GENERAL APPLICATION

Explanation of Request: Site Plan approval to allow for the redevelopment of the Property to a mixed-use project consisting of 58-multifamily units and general office use.

Deandrea Moise, Planner
City of Hollywood
Department of Development Services

Thank you for reviewing this application for the Oak 58 (fka: Hollywood House) mixed-use project. Included in this memorandum, please find the applicant's response to staff's comments in **bold** text.

A2.0

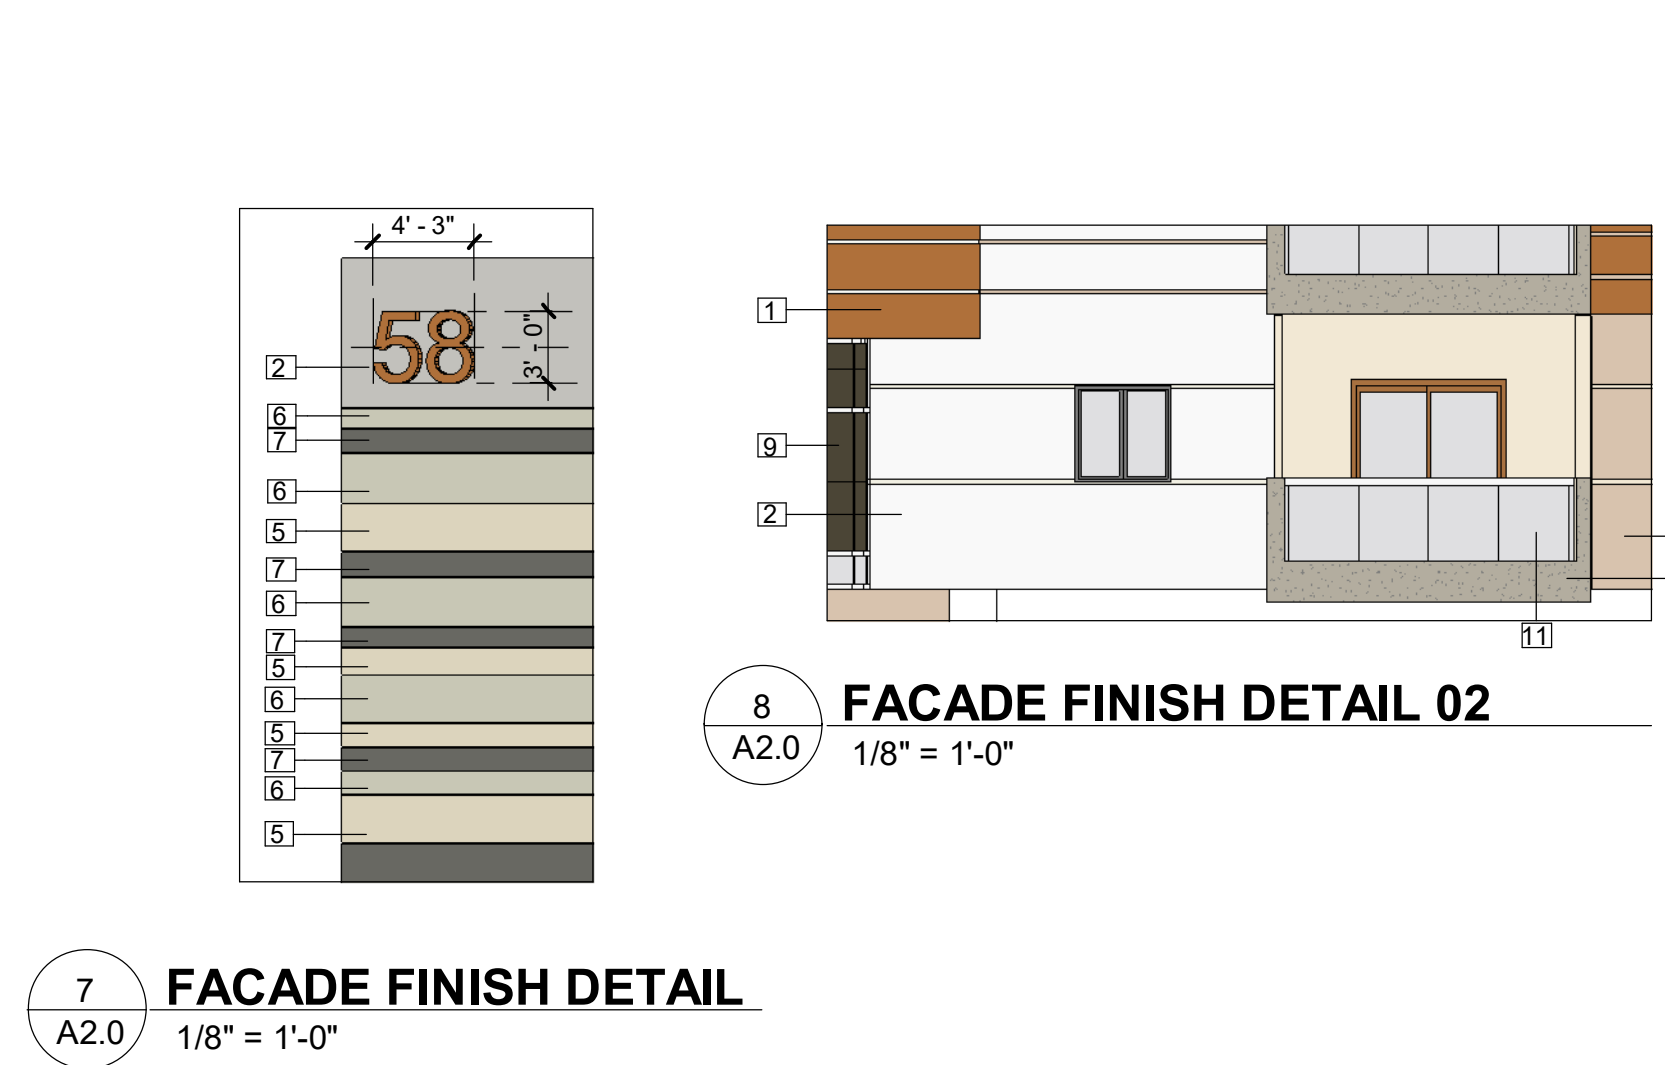
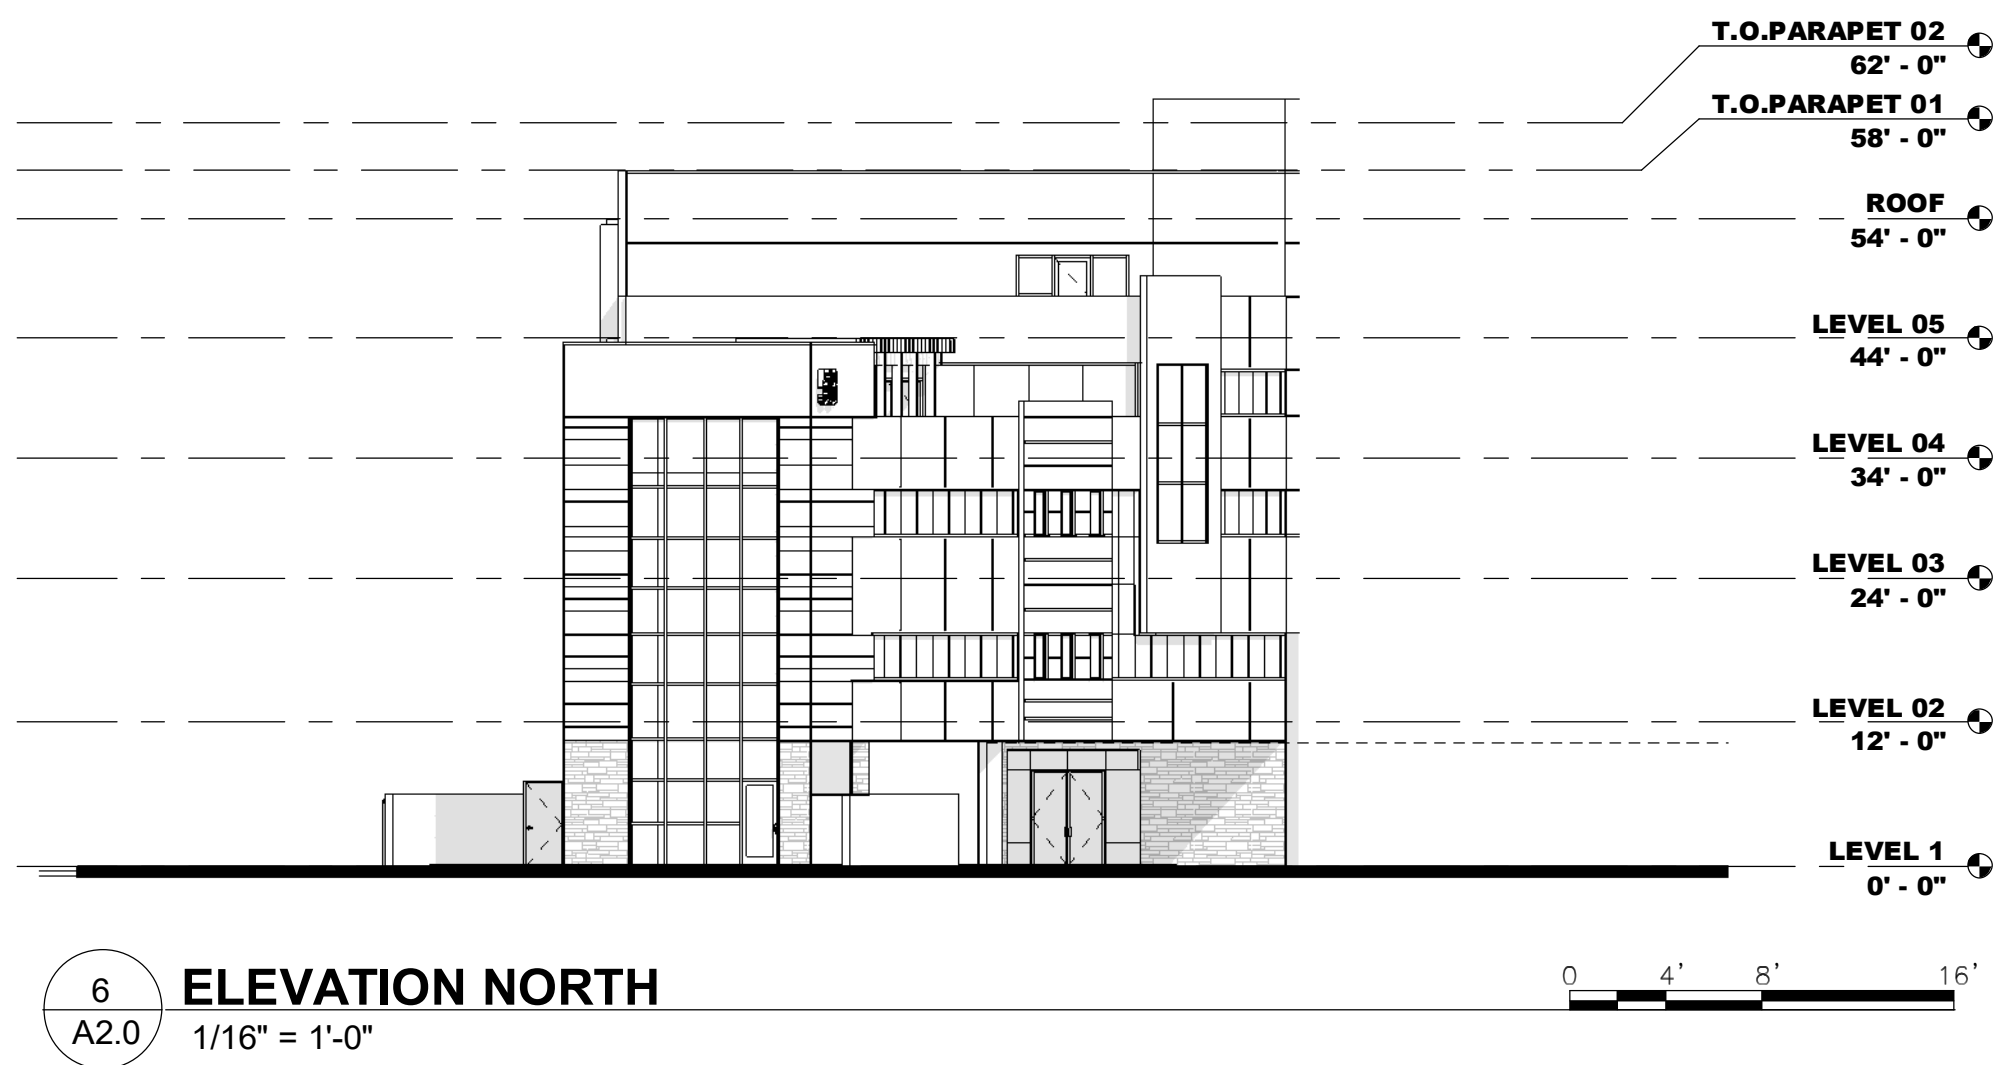
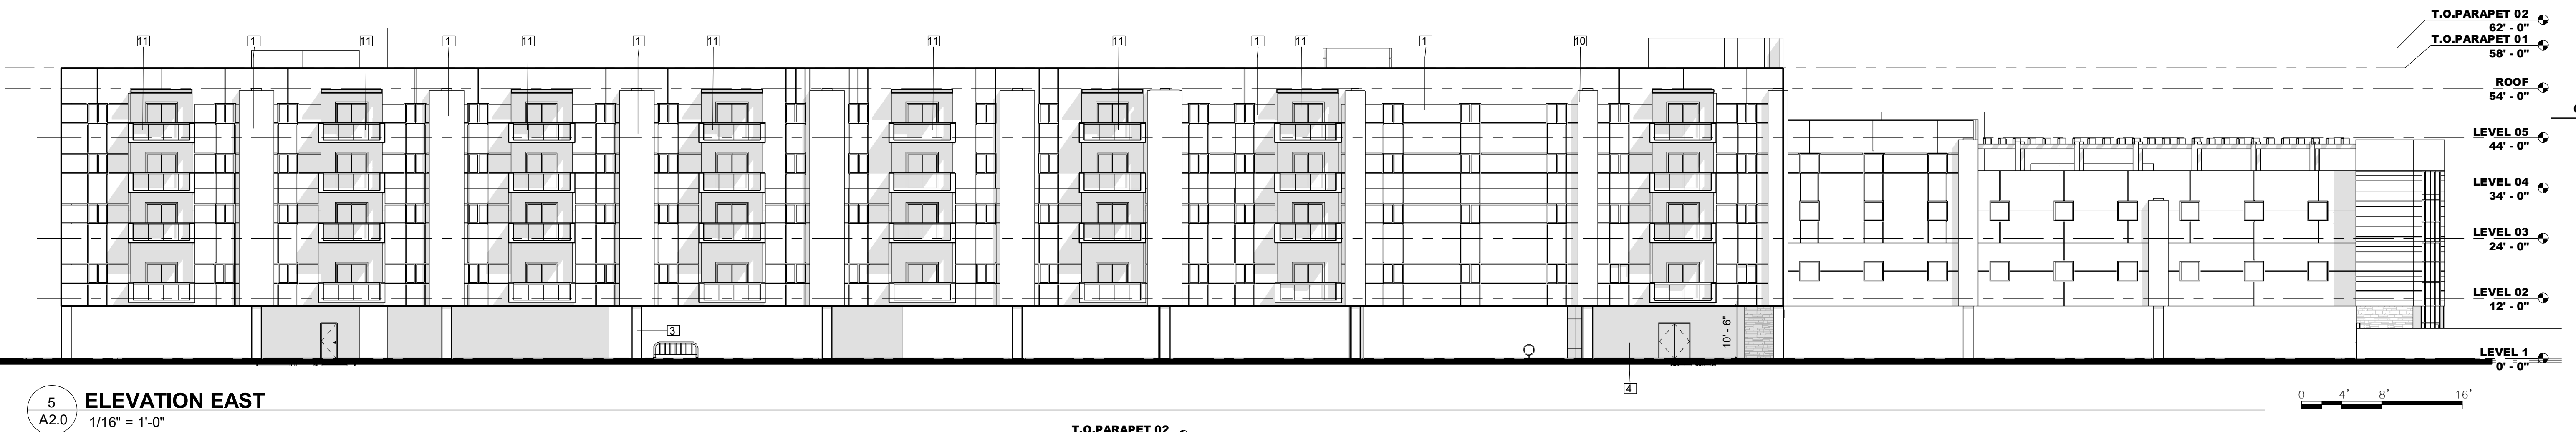
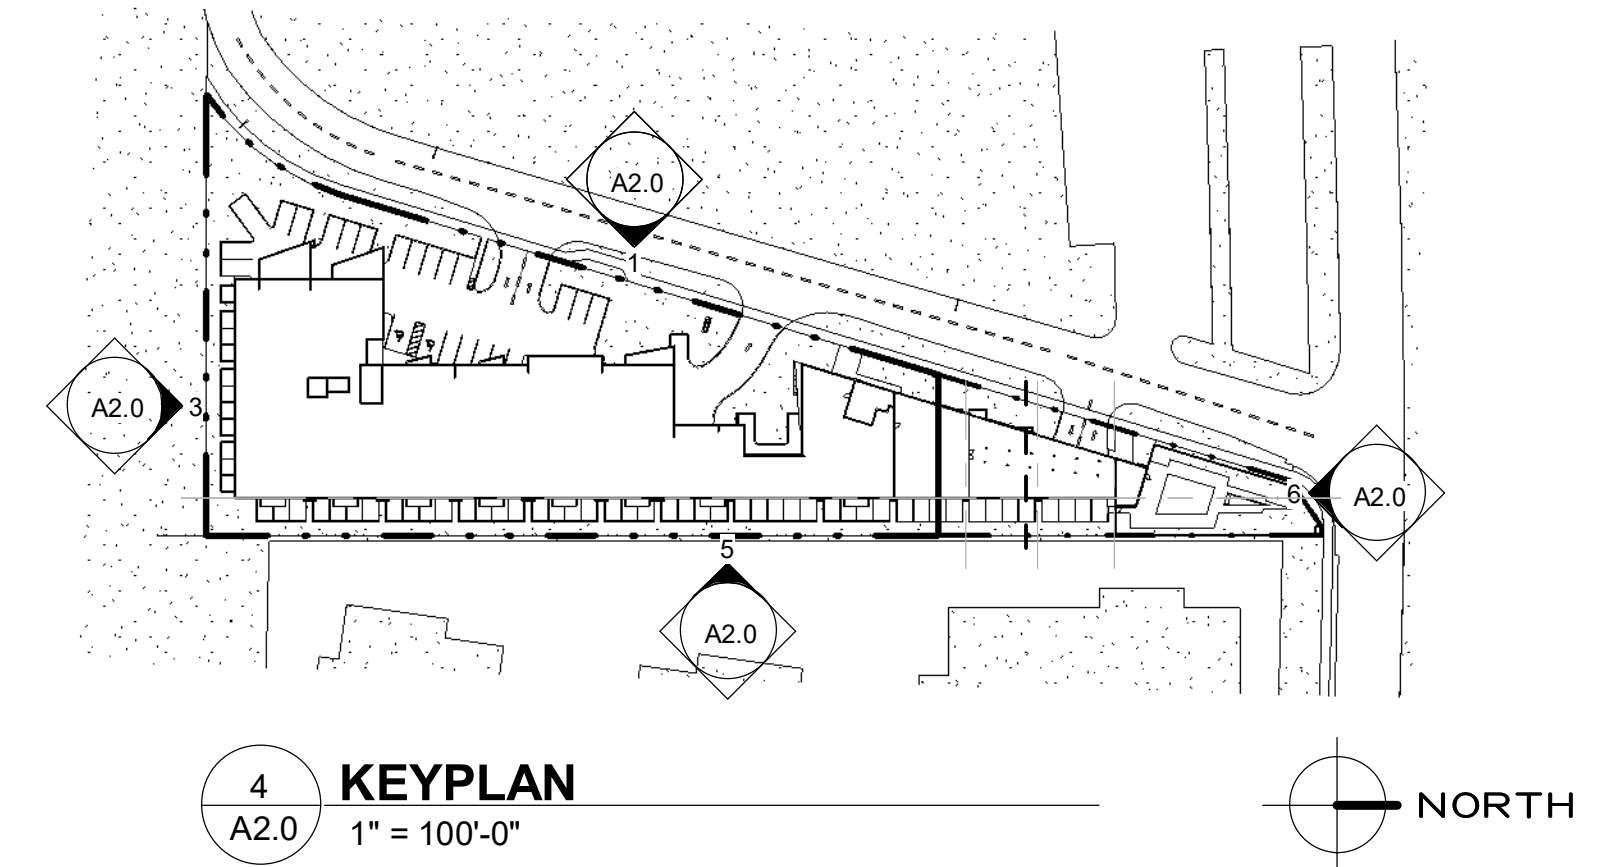
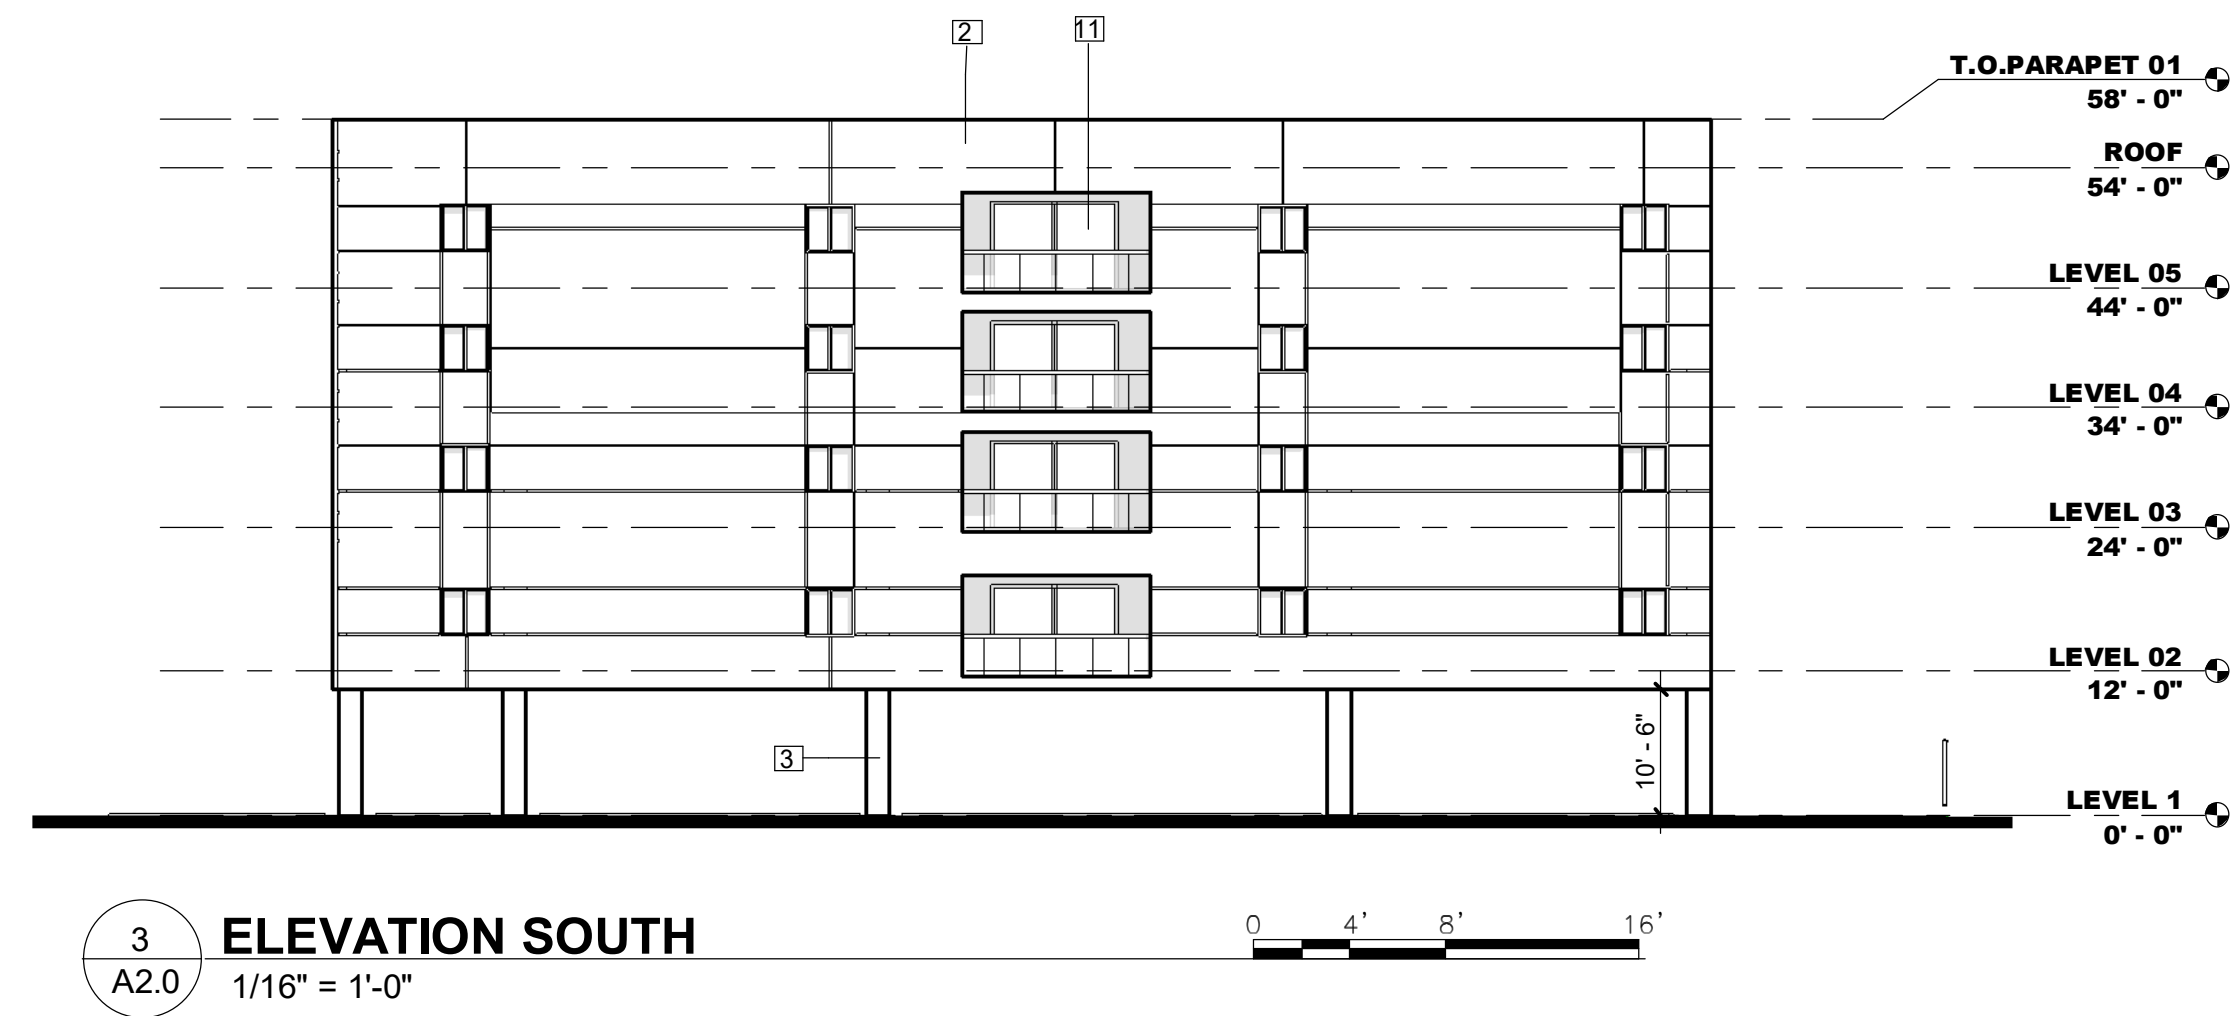
1. For review, full signage package shall be provided, including signage details, signs illustrated on Elevations, dimensions on Site Plan, etc.

Response: Please see sheets A1.1 and A2.0 for the proposed signage.
